Construction Change Directive

(name, address)
ALBERTSONS #2250
WICHITA, KANSAS

DIRECTIVE NO.: S-04

ALBERTSON'S - WICHITA, KS

SHEET
NUMBER
C201.4-1

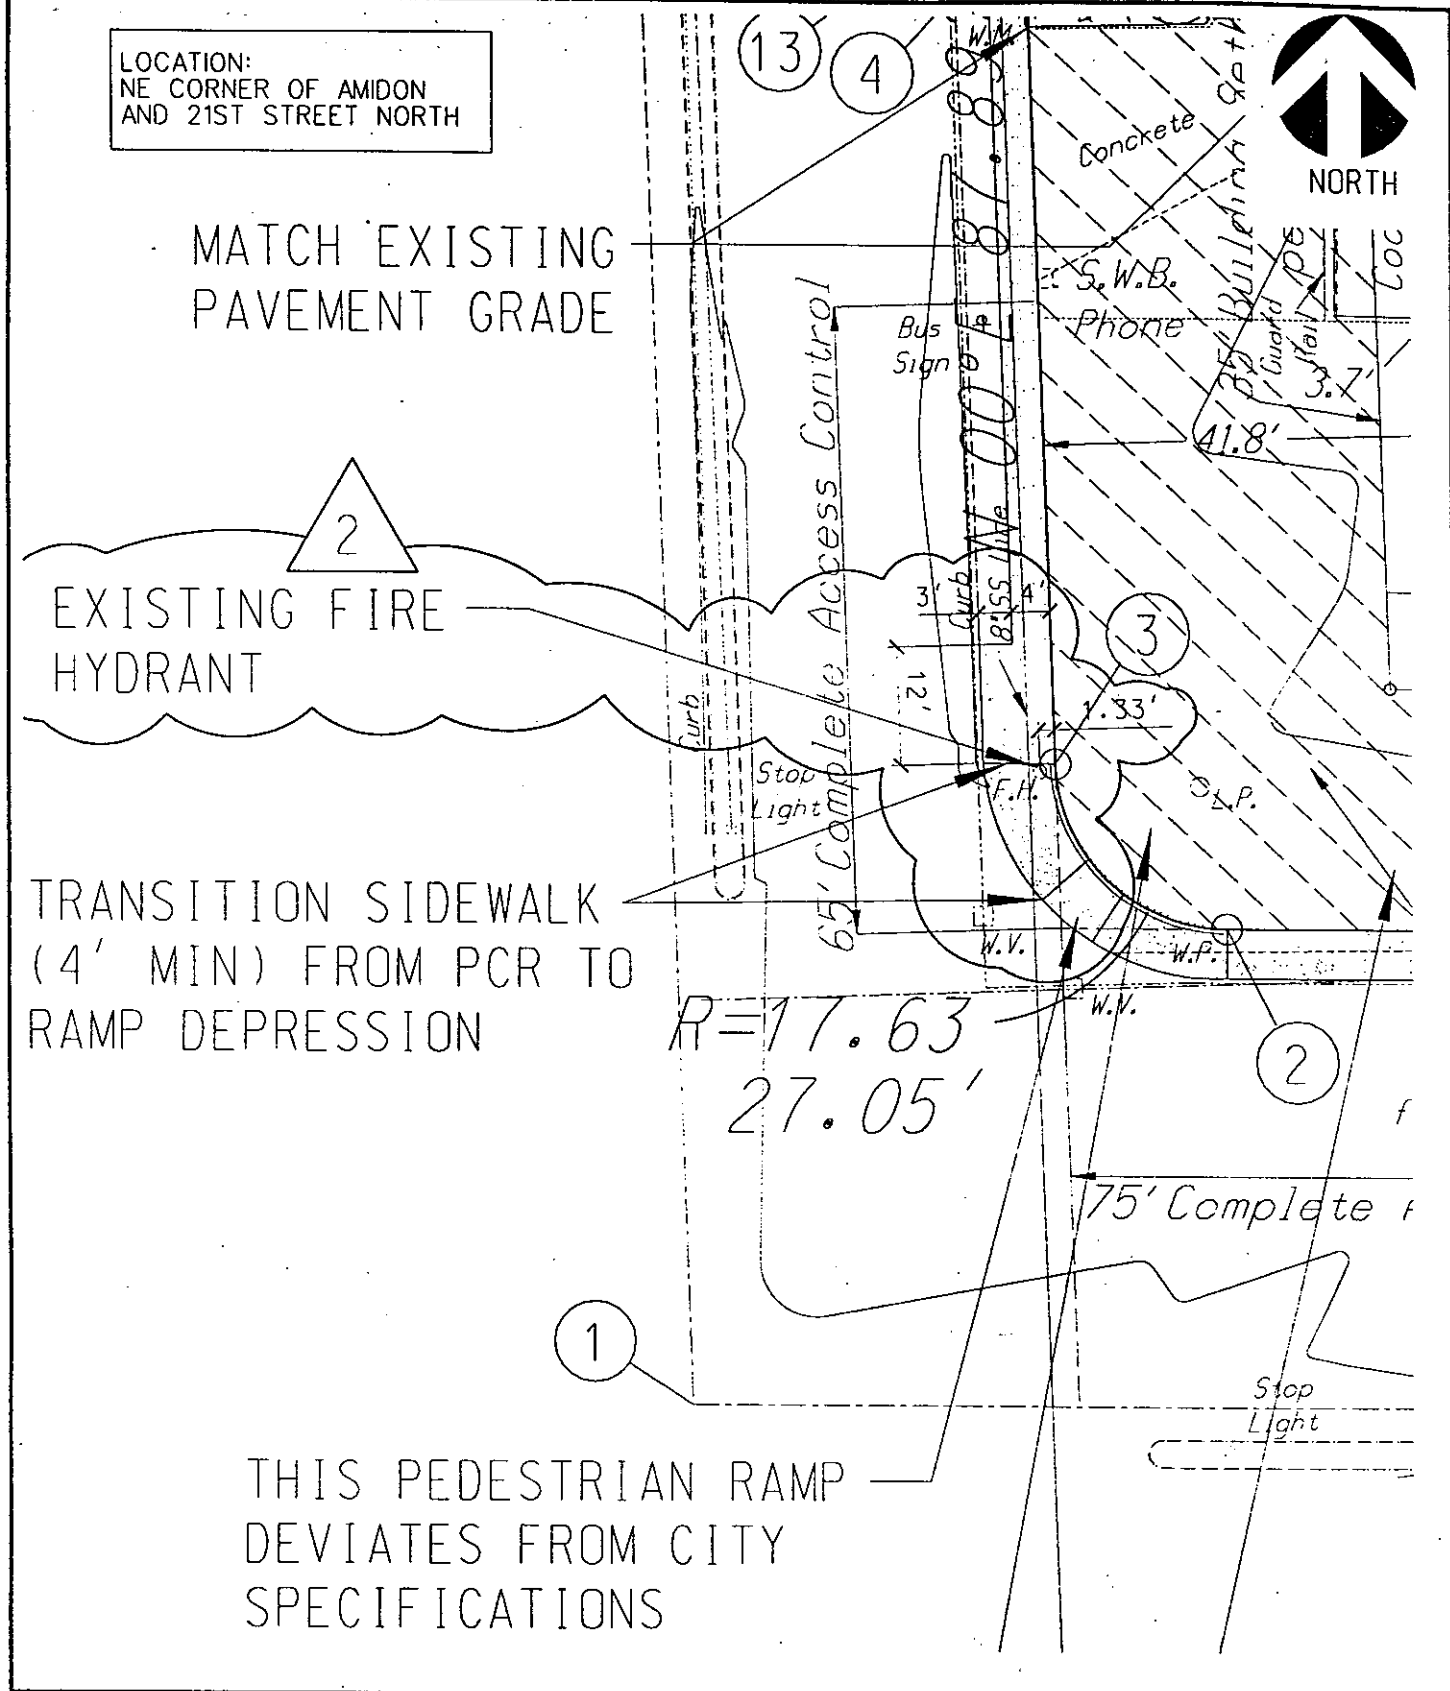
C201, SITE, PAVING, SIGNAGE AND STRIPING PLAN

1. Revised sidewalk on east side of Amidon (west side of project) to provide proper clearance to two existing fire hydrants found to be encroaching into the originally planned sidewalk alignment.

C201.4-5

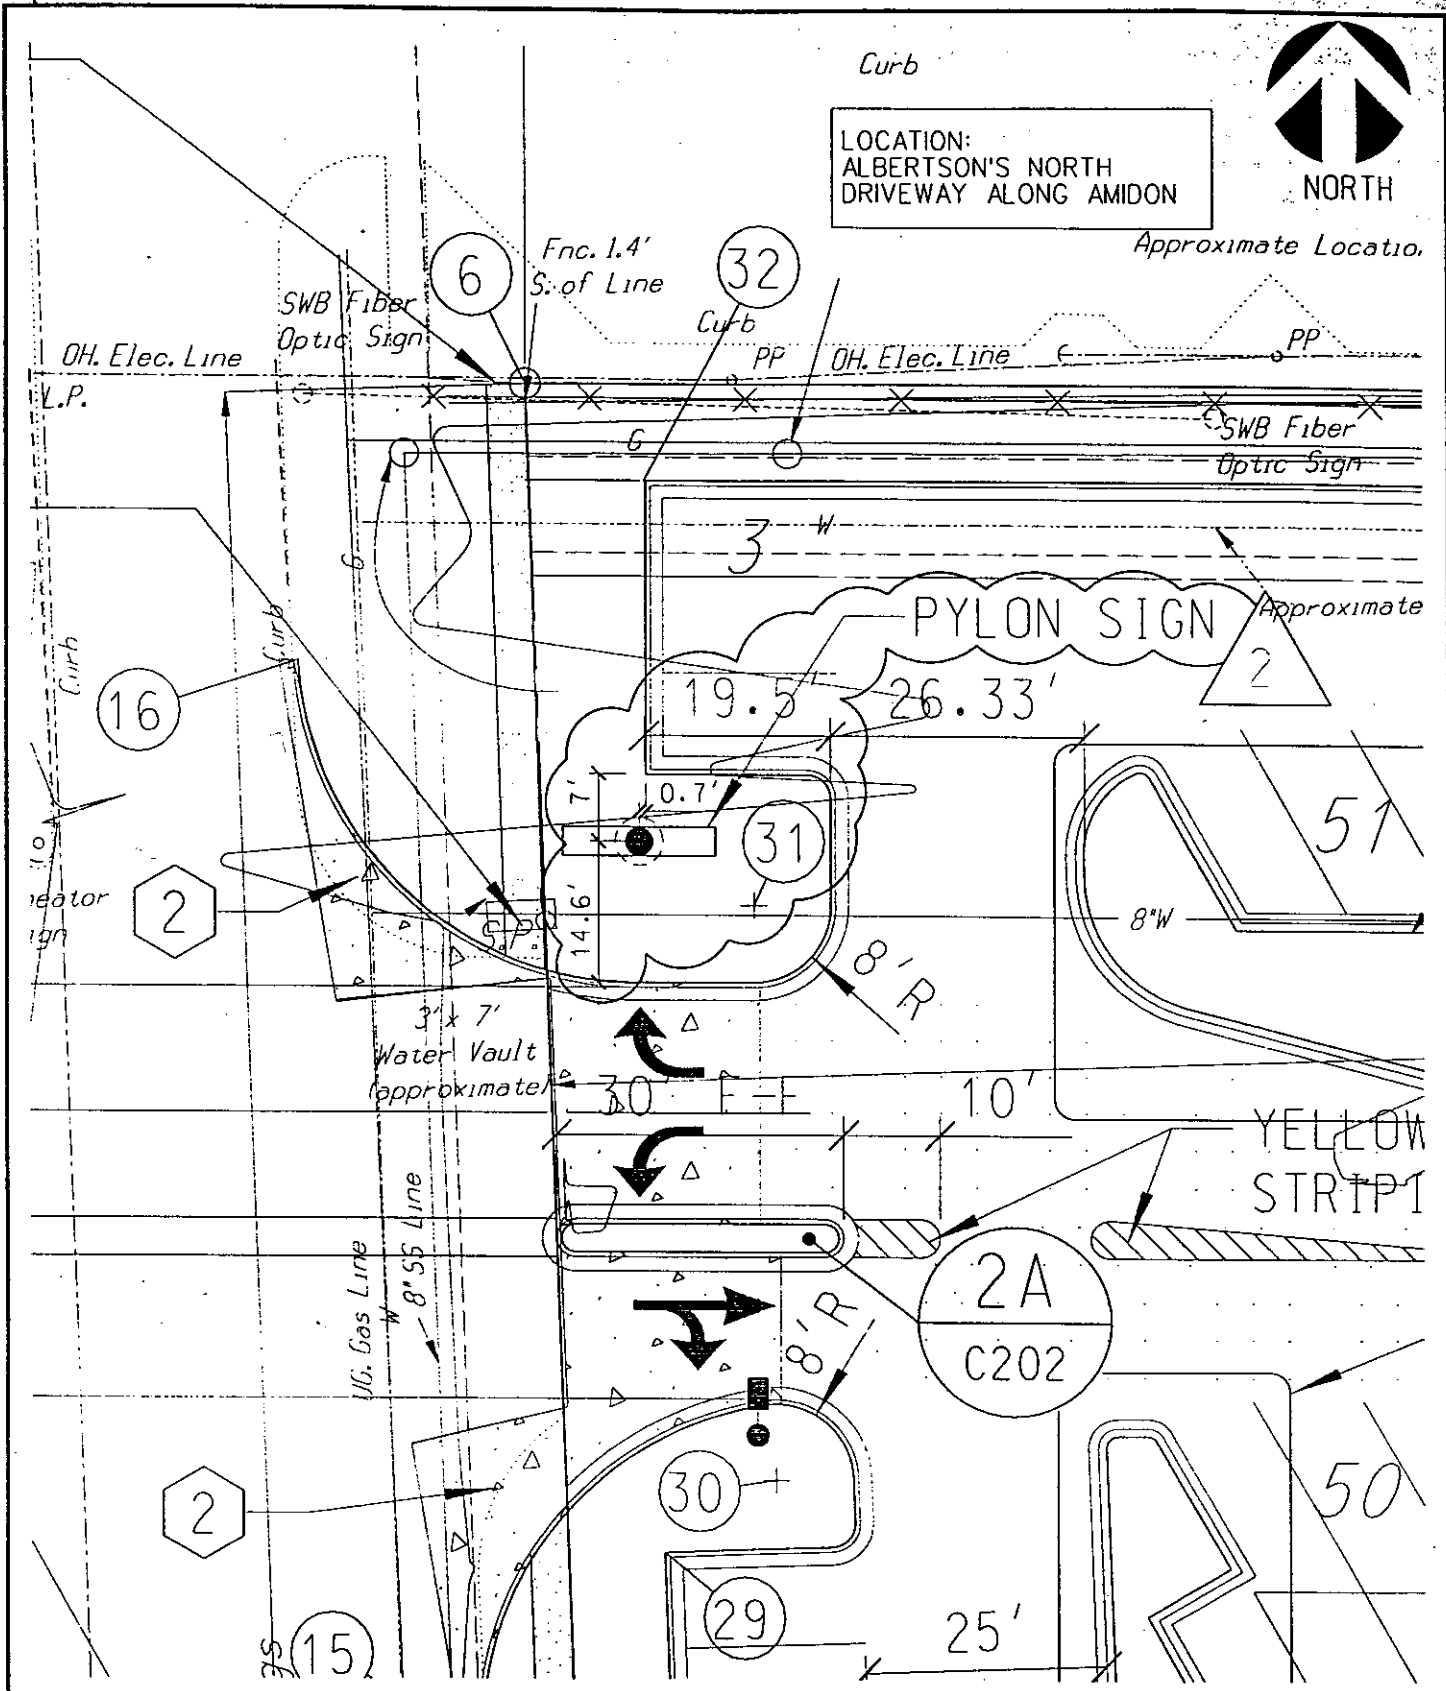
3. Per D.J. Christie's instruction, reduce the depth of the parking stalls located directly south of Shops A to 16 feet in length, thereby increasing the walkway width adjacent to the building.

4. Revise limits of building / site construction around Shops A, including the responsibility for sidewalk construction westerly and adjacent to Shops A (now in D.J. Christie's contract).

5. Noted protection posts for gas meters at the east end of Shops A, as indicated on Jeff Krehbiel Associates plans.
6. Reflected pylon sign relocation (closer to the westerly property line) in the northwest corner of the site, as directed by Image National.

DESIGNED BY: RHR	JOB NUMBER 27000038.250
APPROVED BY: HWF	STORE NUMBER 2250
DATE: 07/03/97	SCALE 1" = 20'
SHEET NUMBER	C201.4-6

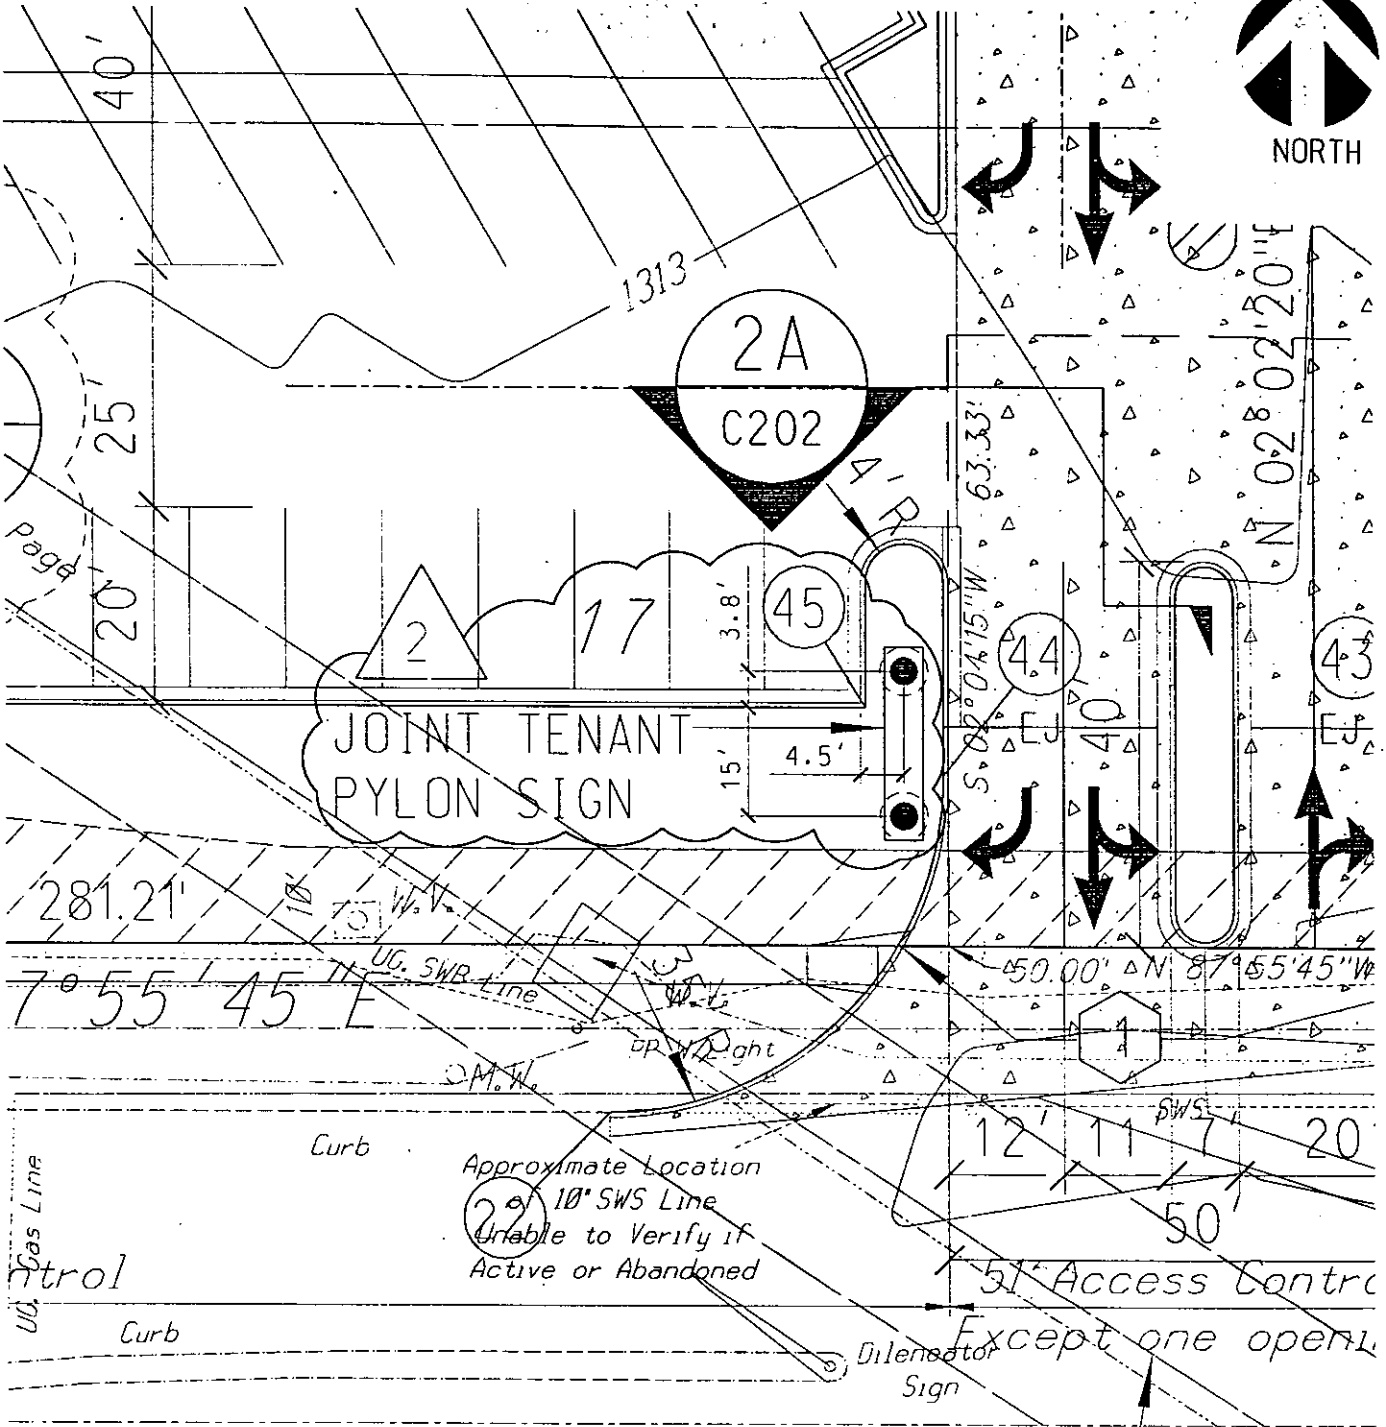
2. Revised northerly curb where the utility pole guy relocation could not be made to clear the original curb alignment. This change caused the elimination of one parking stall and the modification of the island at the east end of the most northerly group of angled parking stalls.

ALBERTSON'S - WICHITA, KS SITE, PAVING, SIGNAGE AND STRIPING PLAN - CCD NO. S-04	DESIGNED BY: RHR	JOB NUMBER 27000038.250
	APPROVED BY: HWF	STORE NUMBER 2250
	DATE: 07/03/97	SCALE 1" = 20'
	SHEET NUMBER	C201.4-7

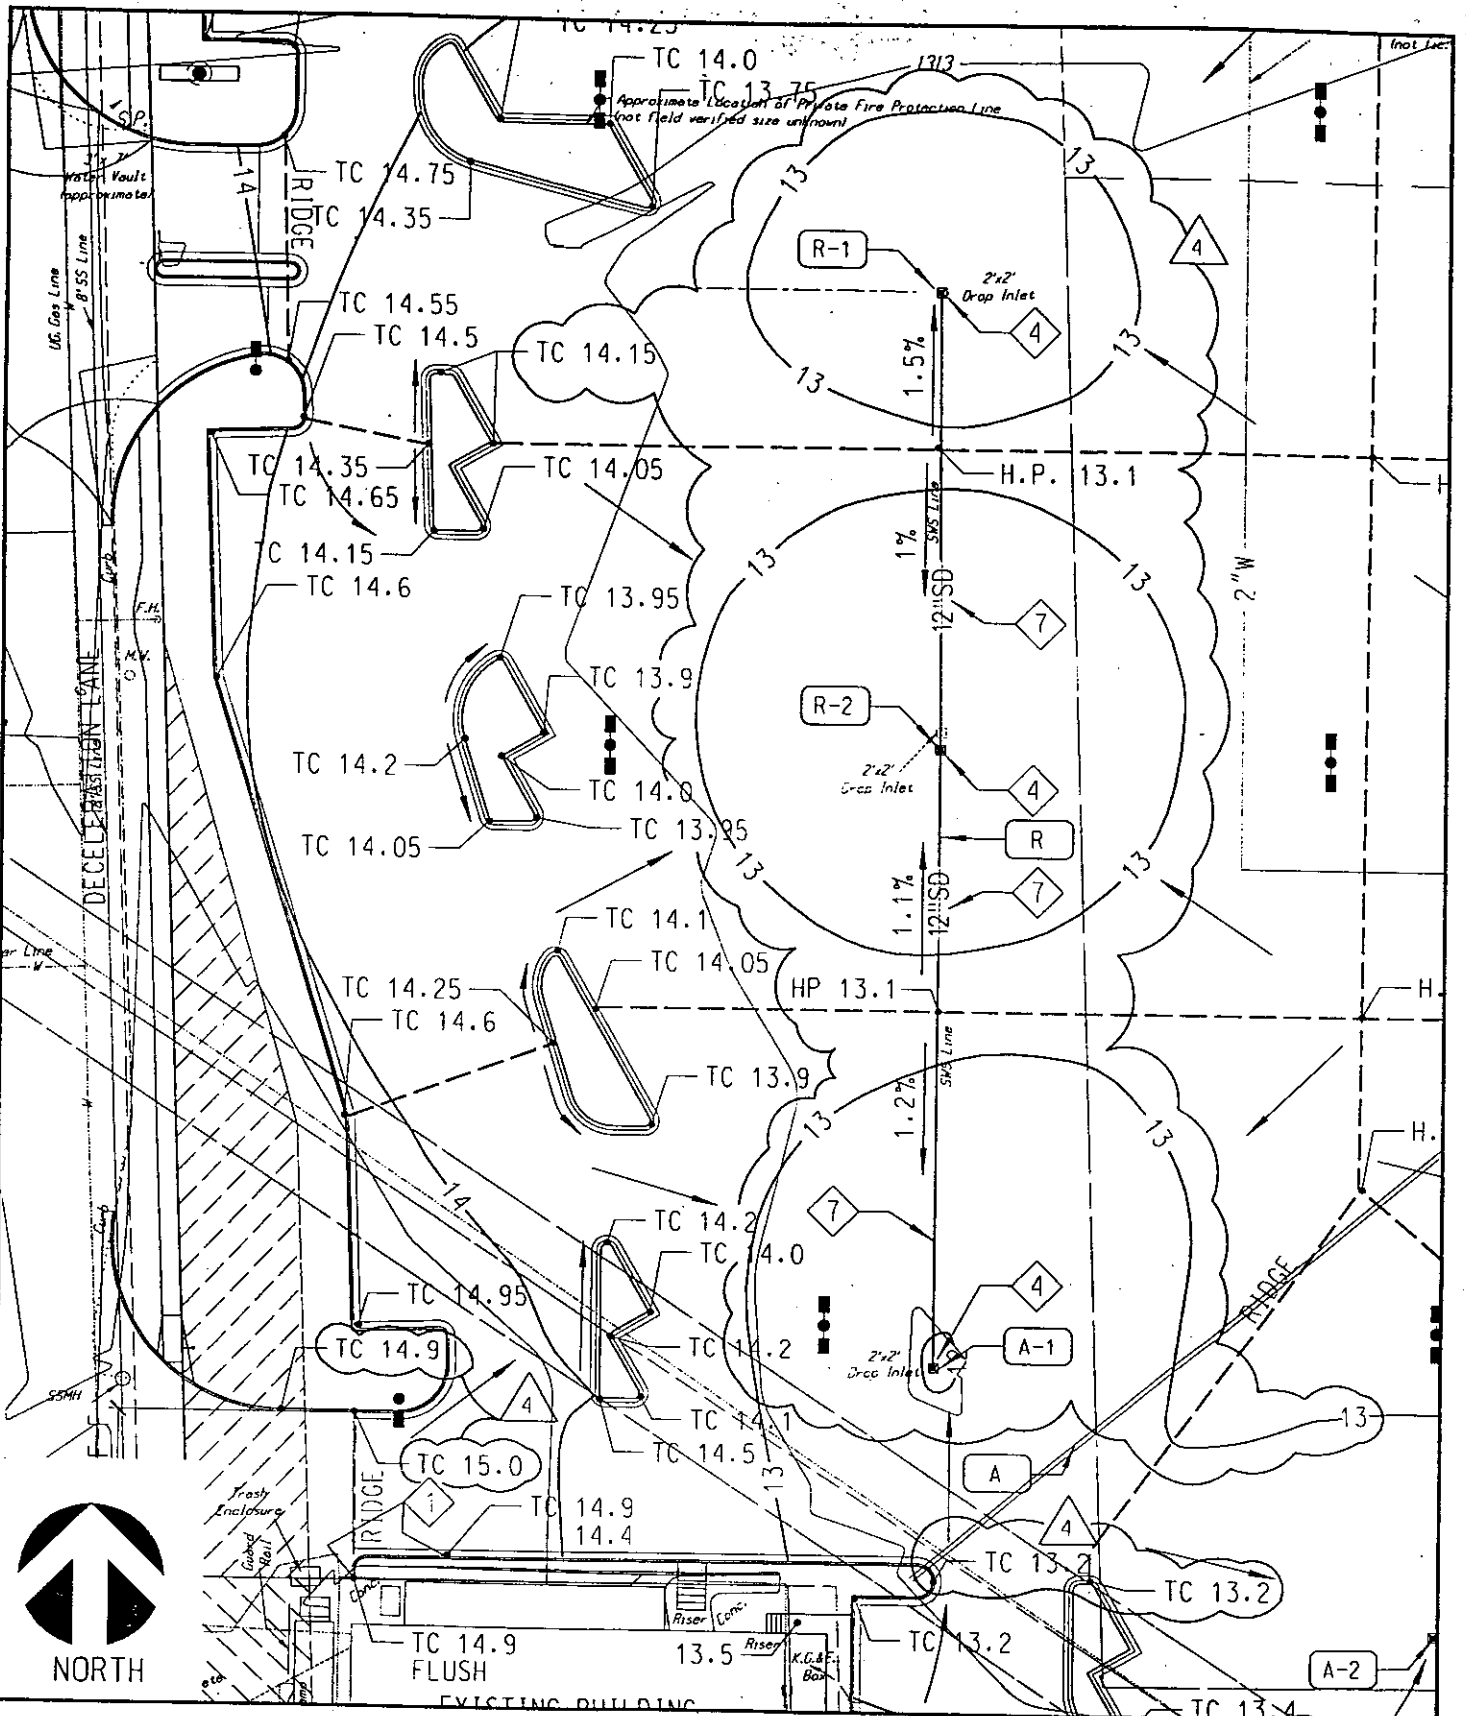
7. Reflected joint tenant sign relocation at the south central driveway off 21st. Street N., as directed by Image National.
